Three Mile Island Nuclear Station, Unit 2 (TMI-2)  
Operating License No. DPR-73  
Docket No. 50-320

Safety Evaluation Report for Sediment Transfer and Processing Operations

**SAFETY ANALYSIS**SA # 4340-3233-85-088Rev. # 2Page 1of 37**TITLE**

SEDIMENT TRANSFER AND PROCESSING OPERATIONS

Figure 1

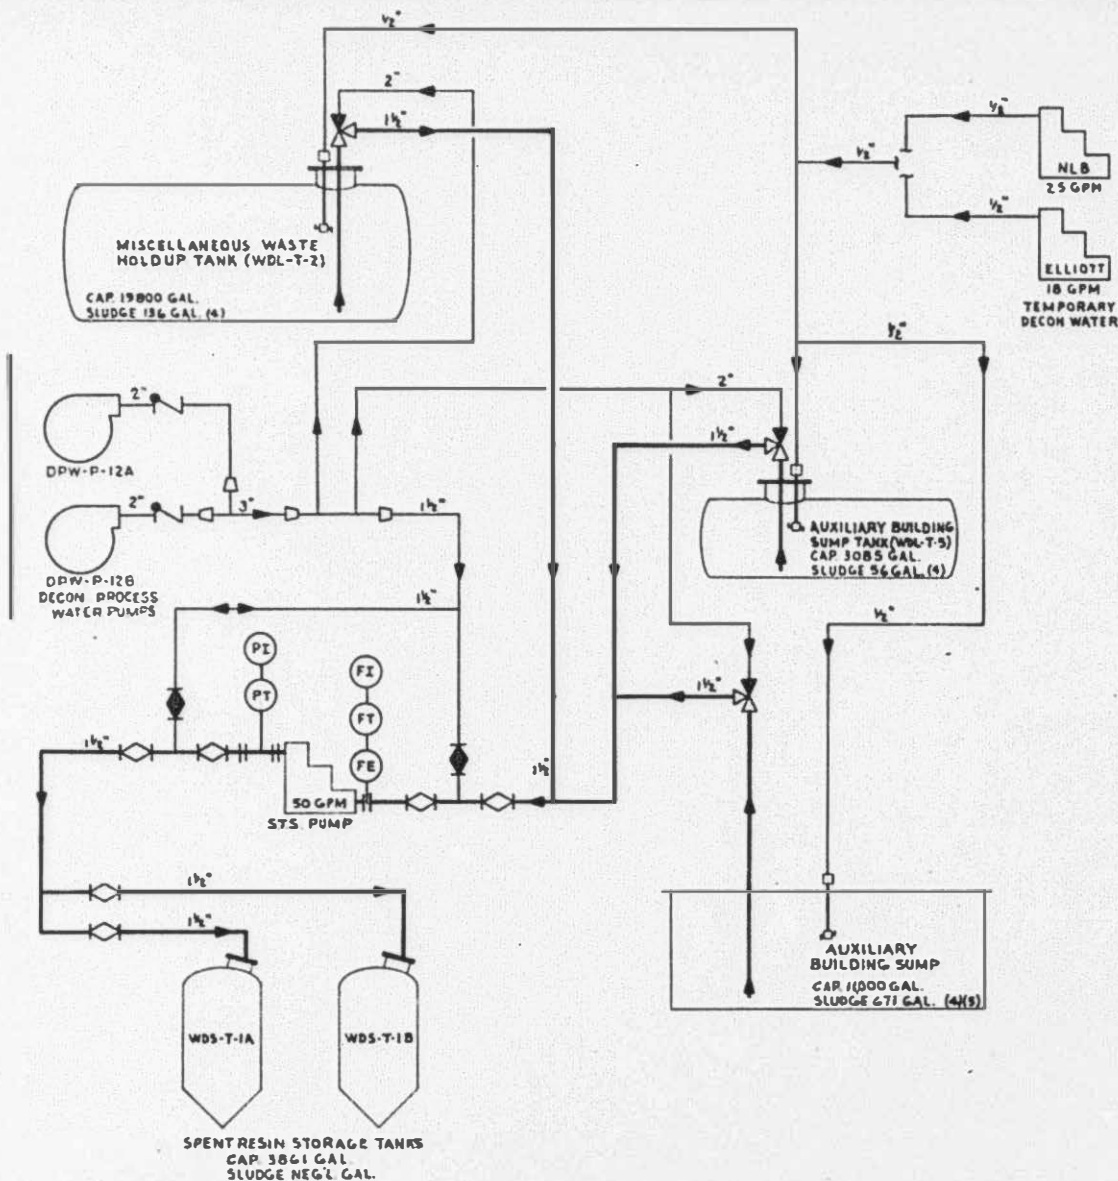
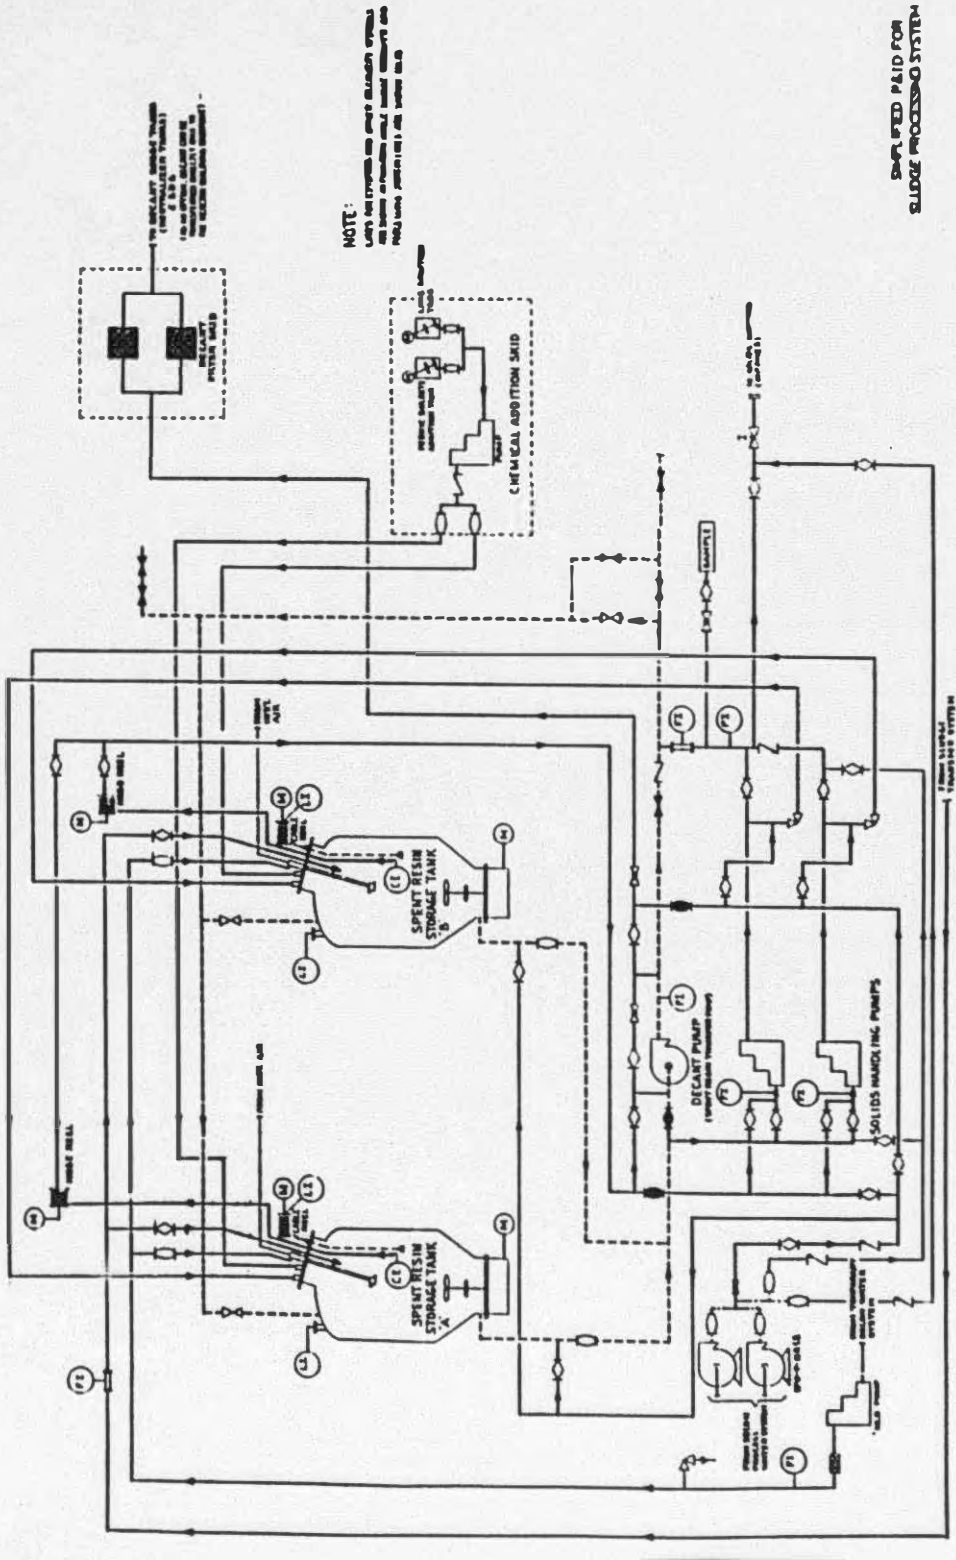
Attached for your review and approval is a revision to the Sediment Transfer and Processing Operations Safety Evaluation Report (SER). To increase operational flexibility, the revision permits supernatant liquid from the Auxiliary and Fuel Handling Building and Reactor Building process operations to be discharged to the Reactor Building. Also, the requirement of redundant level monitors for the Spent Resin Storage Tanks (SRST) has been deleted. The redundancy was originally supplied by the as-built SRST level monitors; however, these monitors are currently out-of-service and it is not planned to repair the level monitors. In addition, the man-rem exposure estimate for installation of equipment and operational testing has also been revised. Other minor changes are as noted in the SER.

Rev.	SUMMARY OF CHANGE	Approval	Date
0	Issued for use.		3/86
1	Revised to permit supernatant liquid from the concentrated sediment to be transferred directly back to the Reactor Building basement without being held in the neutralizer tanks.		6/86
2	Revised to permit supernatant from AFHB and RB process operations to be discharged to the Reactor Building.		2/87
2	Revised to reflect upgrade of the Decon Process Water System.		
2	Revised to increase the manrem exposure estimates for system installation and testing.		
2	Revised to delete the redundant level monitors in the SRST's.

The supernate is drawn into the 1" diameter flexible decant hose using the existing Spent Resin Transfer Pump (WDS-P-1) as the decant pump. The supernate is pumped at a rate of approximately 15 gpm through the decant filter skid which includes two backflushable filters in parallel, that are designed to remove all particles larger than approximately 20 microns. After filtration, the liquid is transferred to the Neutralizer Tanks and processed through the SDS. As an option, supernate from the processed sludge can be transferred directly to the reactor building basement without being held up in the neutralizer tanks.
